Intel[®] 82803AA Memory Repeater Hub for RDRAM* Devices(MRH-R)

Specification Update

Document Number: 298181-004

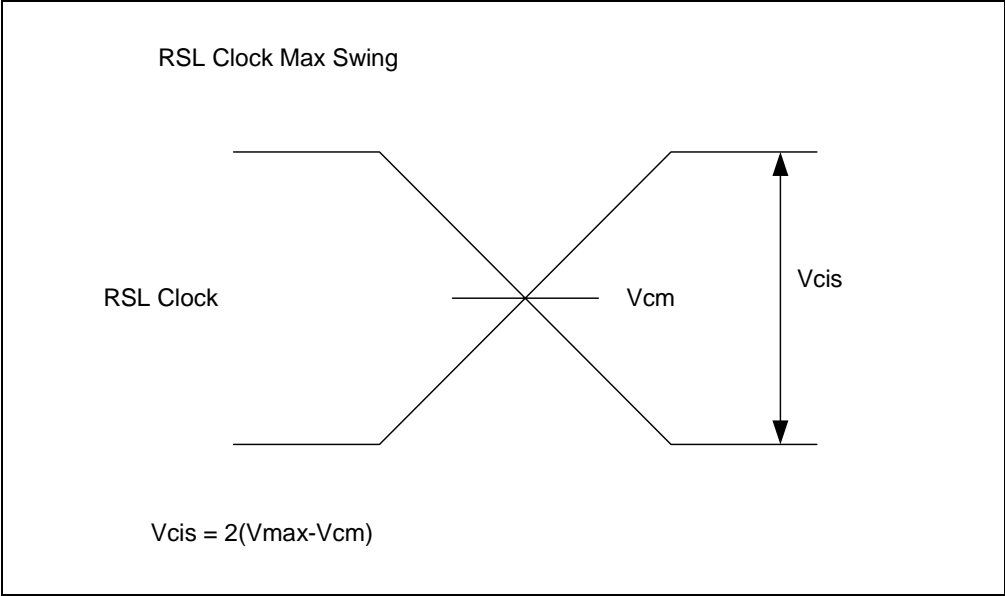
1. Vterm provided externally of MRH-R. It carries a nominal value of 1.8 V.
2. Vref has a nominal value of 1.4 V
3. Vcis = 2(Vmax-Vcm), where: Vcis = Maximum clock input voltage swing, Vcm = Voltage common mode, Vmax = 2.2 V. See figure below.
